INFINIX MOBILITY LIMITED

Subject: FCC Class II Permission change for FCC ID: 2AIZN-X6858

This is to request a Class II permission change to our Mobile Phone; Model: X6858, FCC ID: 2AIZN-X6858, the device is identical to the previously certified except for the changes as below for details:

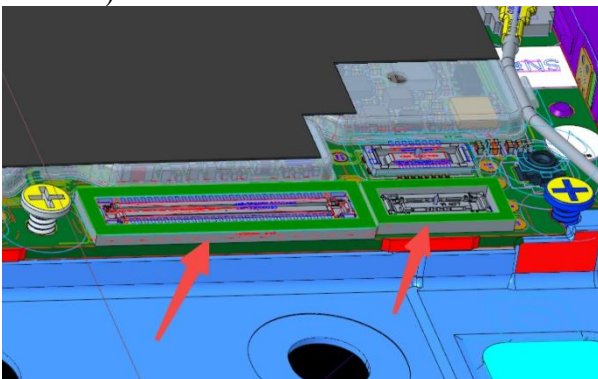
1. WPT Antenna: Enlarged appearance (The FPC is lengthened by 1.8mm, the coil remains unchanged, and the wireless coil charging power is not affected);
2. LED FPC, Reduced appearance (The FPC is shortened by 3.7mm and the width is increased by 1mm. The appearance is changed but the function is not affected.)
